**Environmental
Planning
Commission**

**Agenda Number: 02
Project Number: 1004167
Case Number: 17EPC- 40048
Hearing Date: October 12, 2017**

Staff Report

Agent	Daniel Puzak, AIA and Jonathan Turner
Applicant	Legacy Home Health
Request	Site Development Plan for Building Permit
Legal Description	Lot 2 of Bosque Plaza
Location	Bosque Plaza Lane southeast of the corner of Coors Blvd. NW and La Orilla Road NW
Size	2 acres
Existing Zoning	C-1 (SC) (Neighborhood Commercial Shopping Center)
Proposed Zoning	No Change

ARCHITECTURAL SITE PLAN

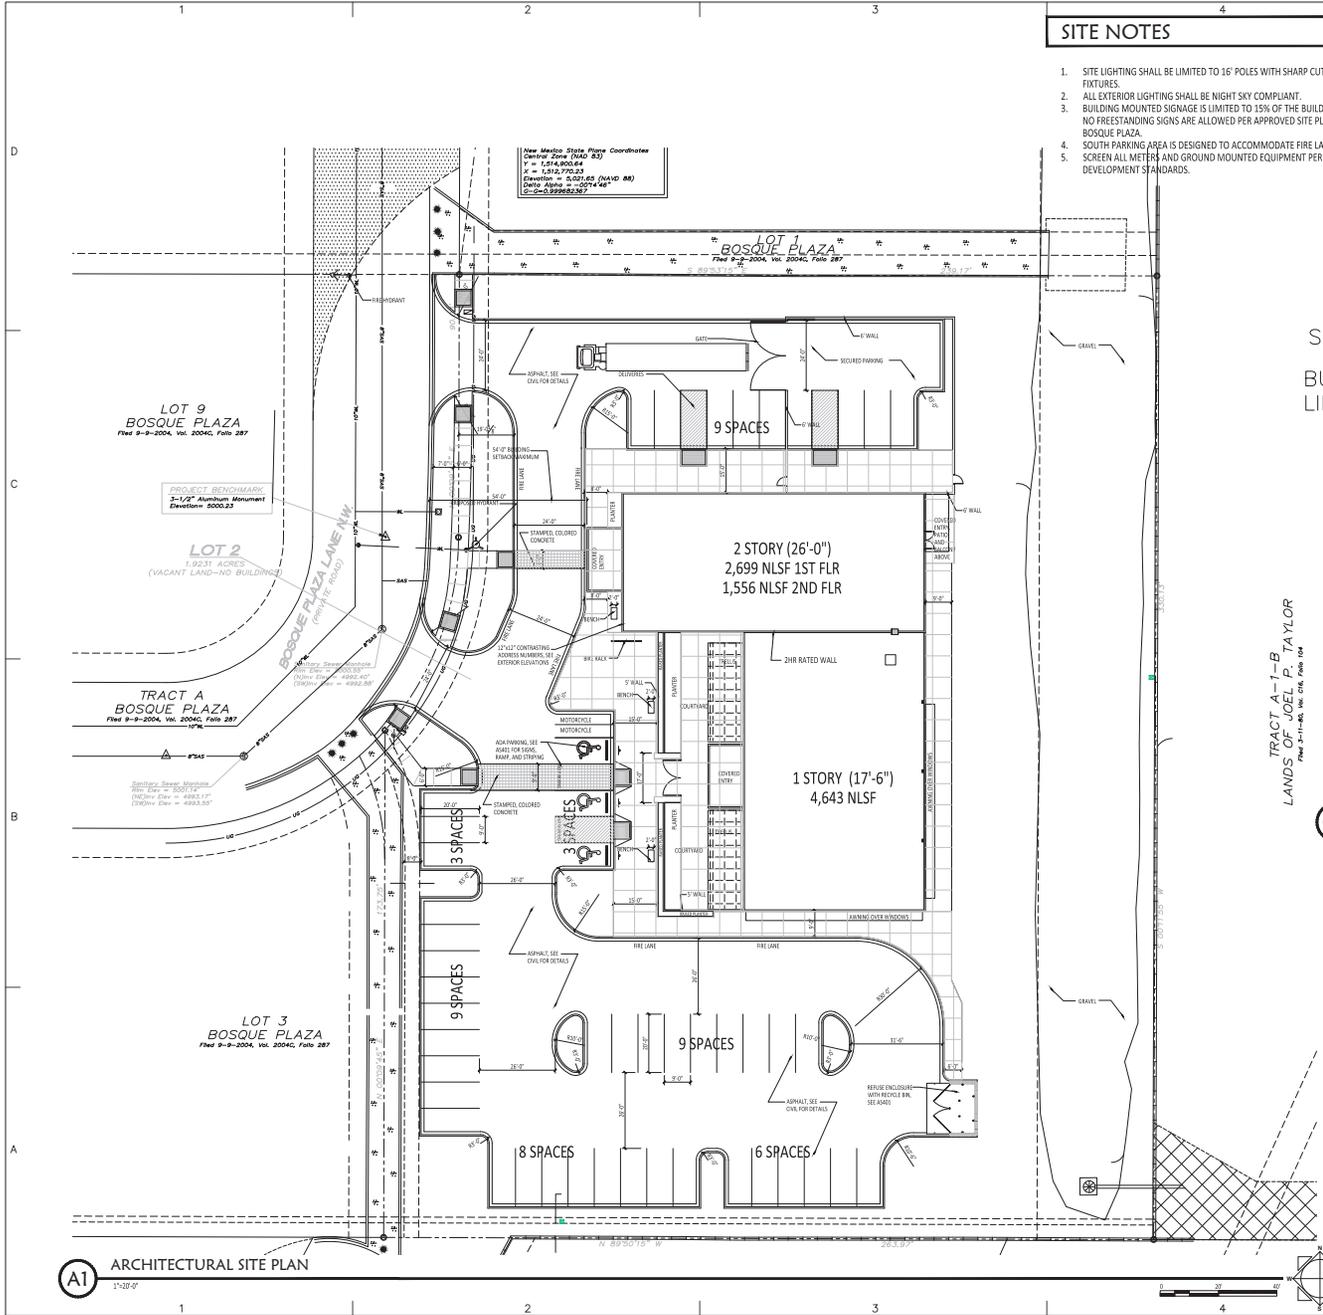
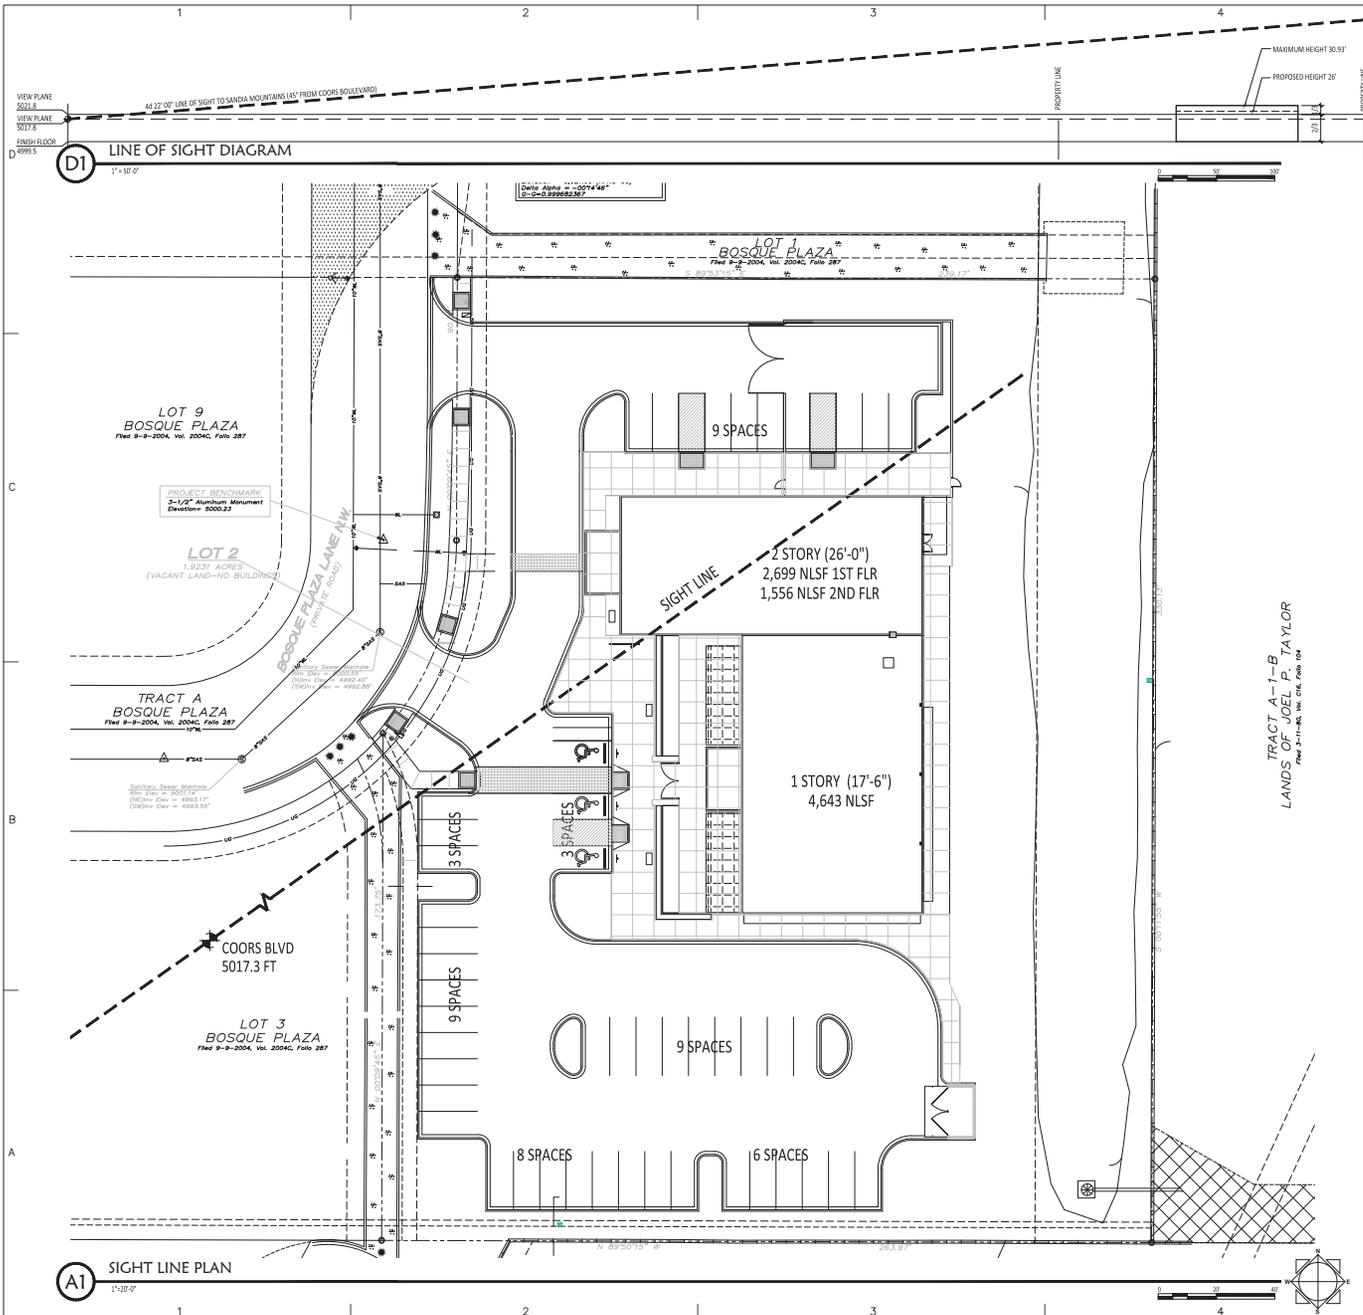
2. Prior to application submittal to the DRB, the applicant shall meet with the staff planner to ensure that all conditions of approval are met.
3. The Architectural Site Plan shall be re-labeled "Site Plan for Building Permit".

4. Per Zoning Code 14-16-3-1 (H) (1), pedestrian walkways shall be lined with adjacent shade trees. Trees shall be added to the landscape strip between the pedestrian connection to Winter Haven and the parking lot to meet this requirement. In addition, one tree shall be added to the landscape island closer to the pedestrian connection that leads to the building entrance just north of the pedestrian connection entrance.

MISCELLANEOUS
 DETAILS

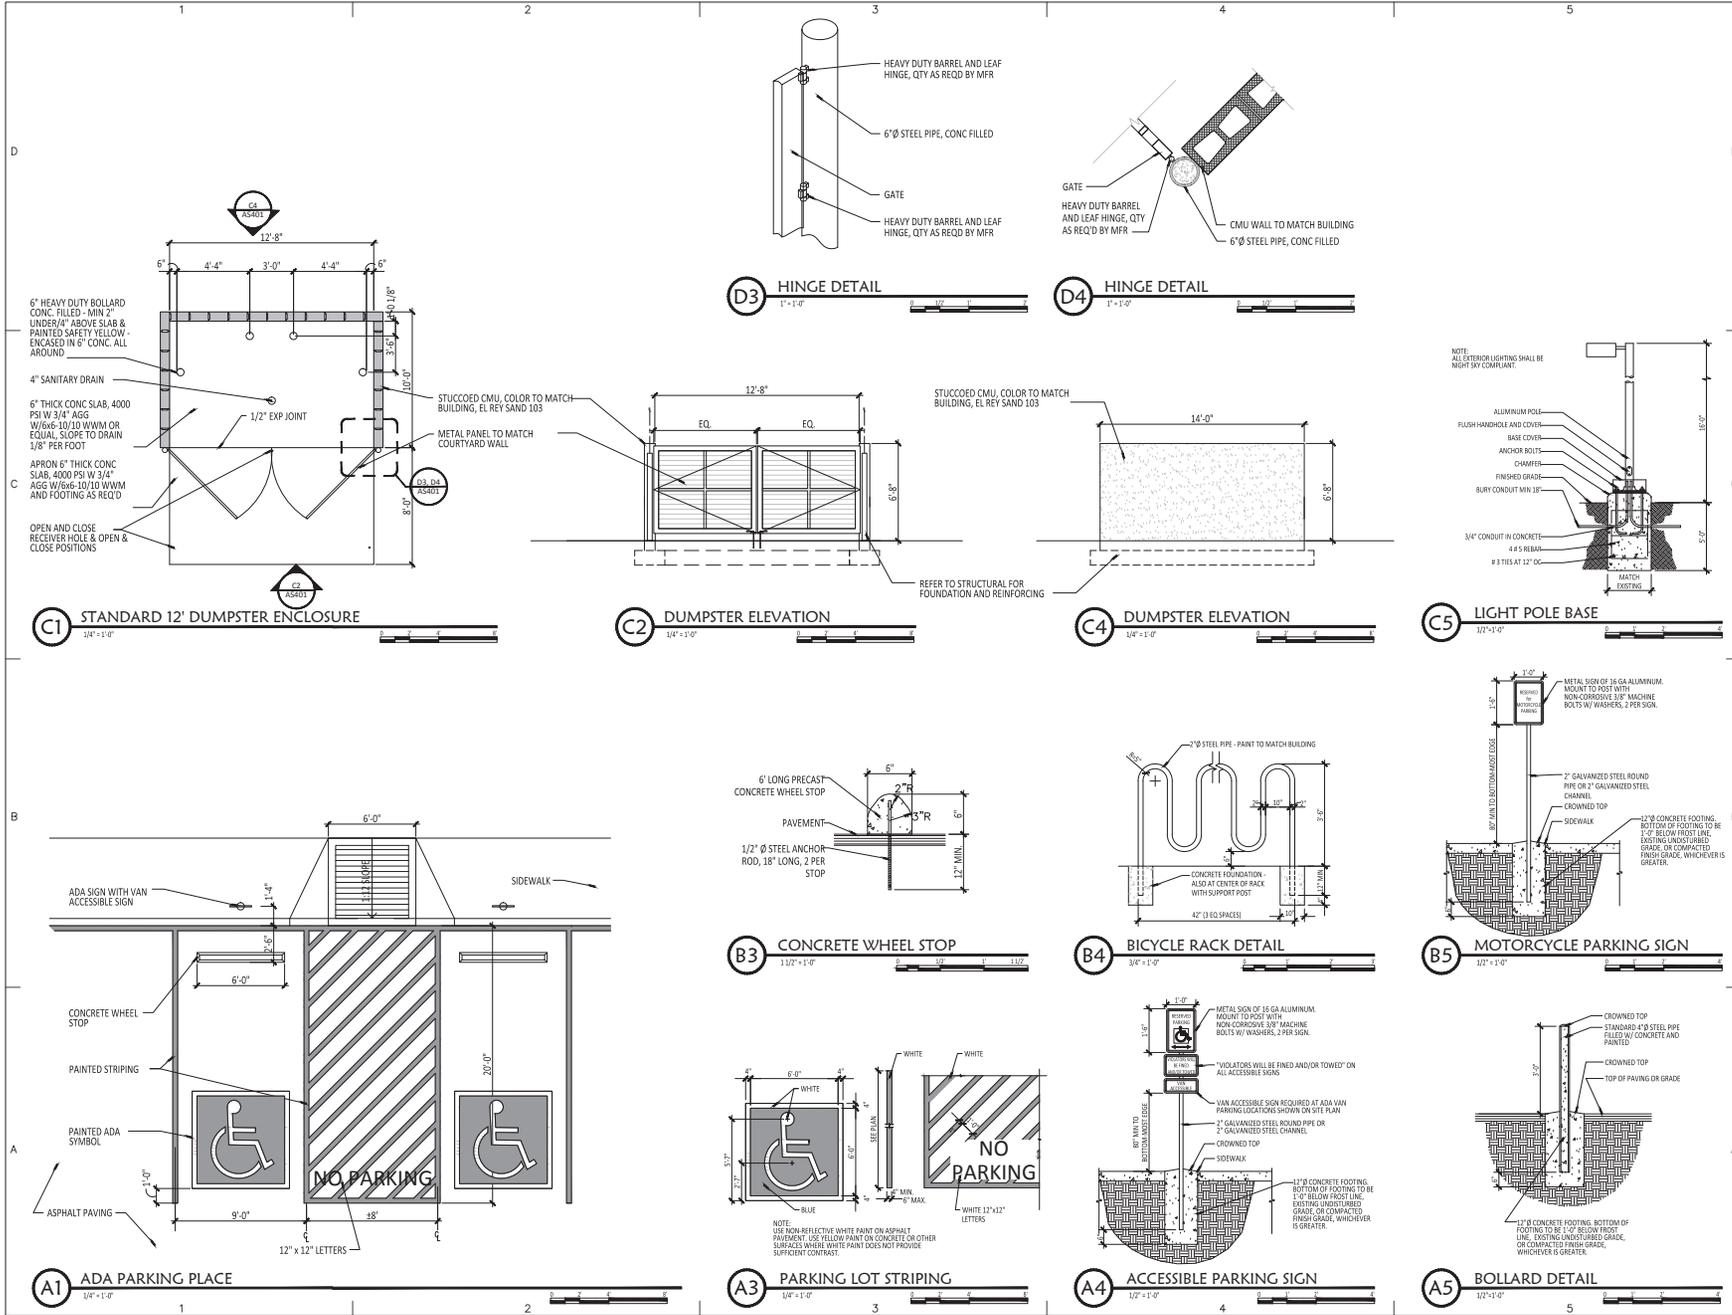
10. It is not apparent what type of pavement surface is being proposed. Please provide detail per the zoning code.
11. The ADA accessible parking sign must have the required language per 66-7-352.4C NMSA 1978 "**Violators Are Subject to a Fine and/or Towing.**" Please call out detail and location of HC signs.

1. It is not apparent what type of pavement surface is being proposed. Please provide detail per the zoning code.
2. The ADA accessible parking sign must have the required language per 66-7-352.4C NMSA 1978 "**Violators Are Subject to a Fine and/or Towing.**" Please call out detail and location of HC signs.
3. The ADA access aisles shall have the words "**NO PARKING**" in capital letters, each of which shall be at least one foot high and at least two inches wide, placed at the rear of the parking space so as to be close to where an adjacent vehicle's rear tire would be placed. (66-1-4.1.B NMSA 1978)

EXTERIOR ELEVATIONS

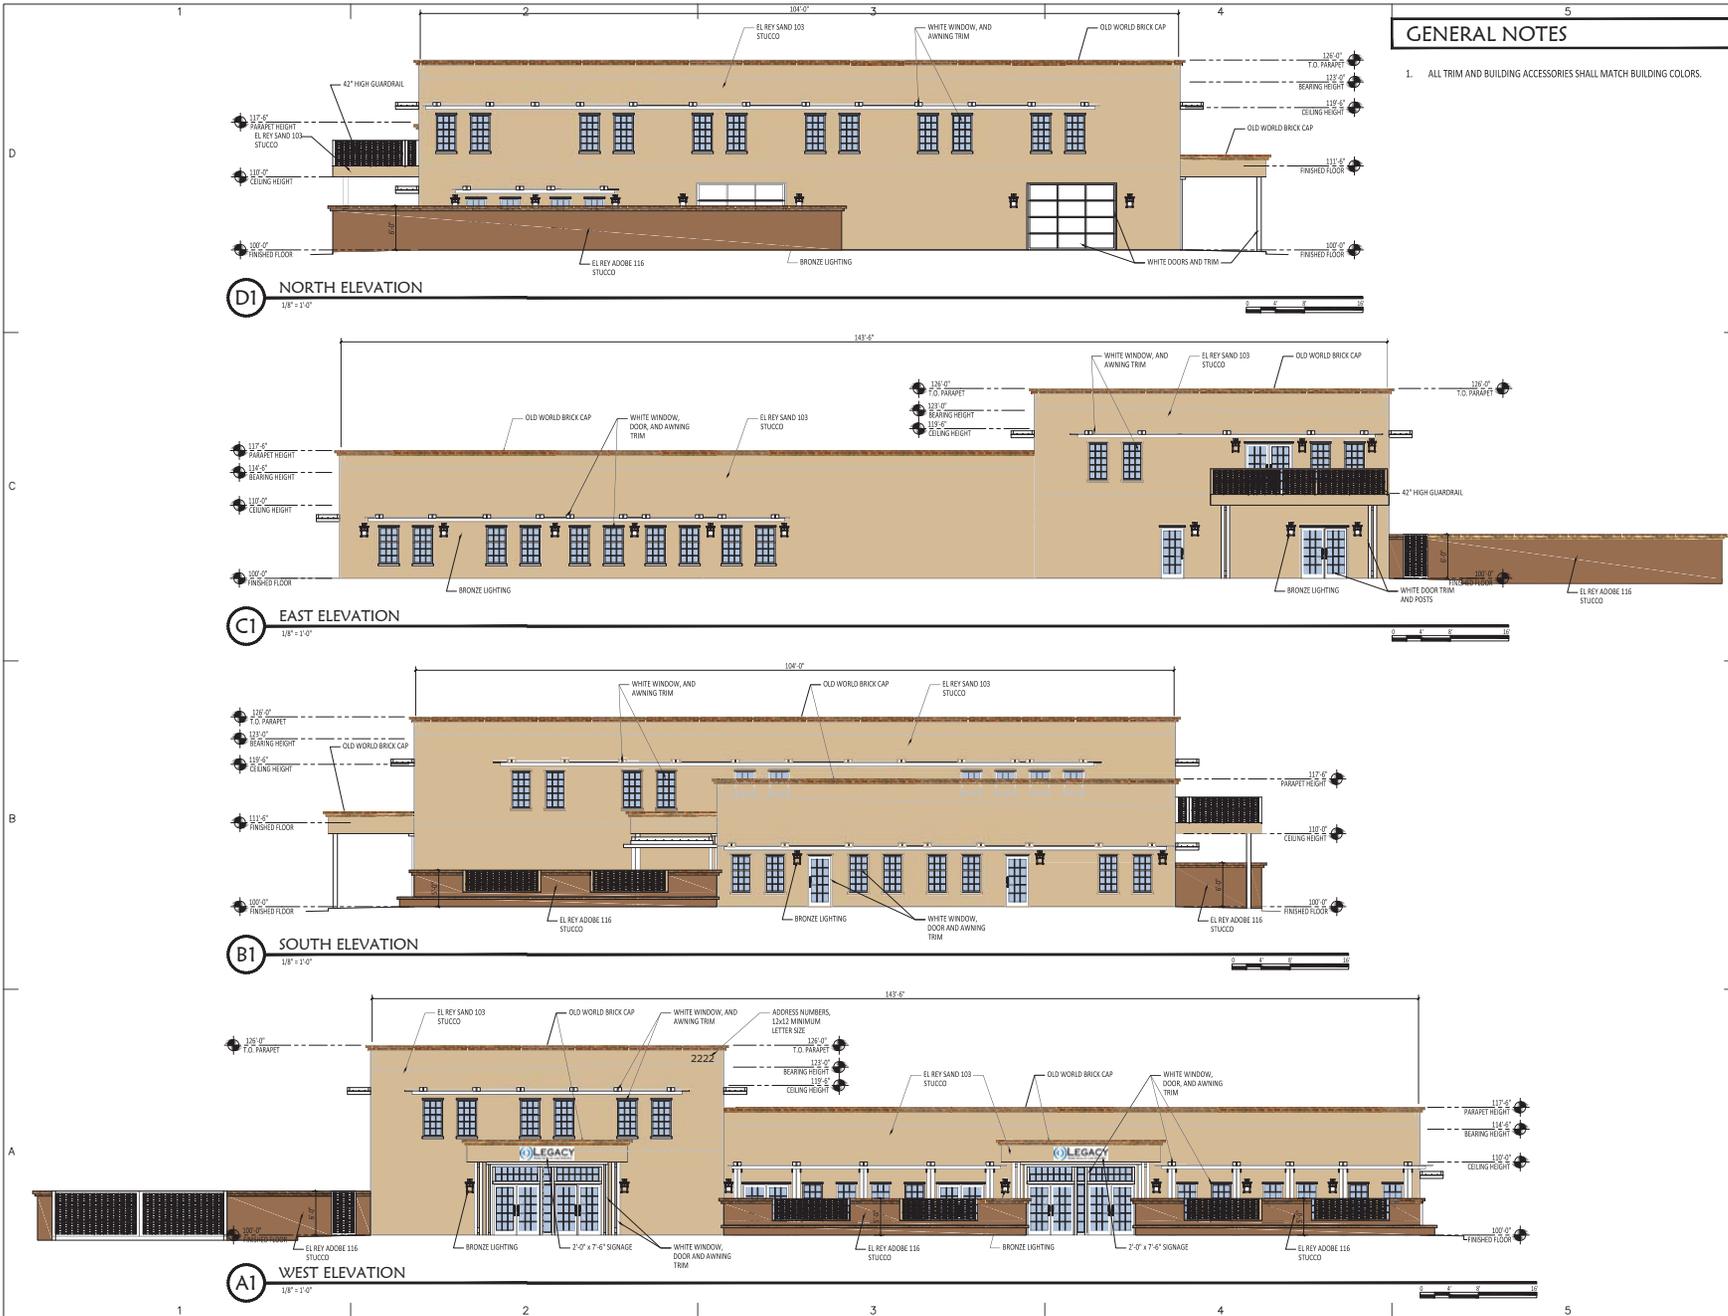
7. A note shall be added on the Elevations under General Notes "Individual building-mounted signs shall have an area not to exceed 6% of the façade to which it is applied. All signage shall be designed to be consistent with and complement the materials, color, and architectural style of the building or site location."
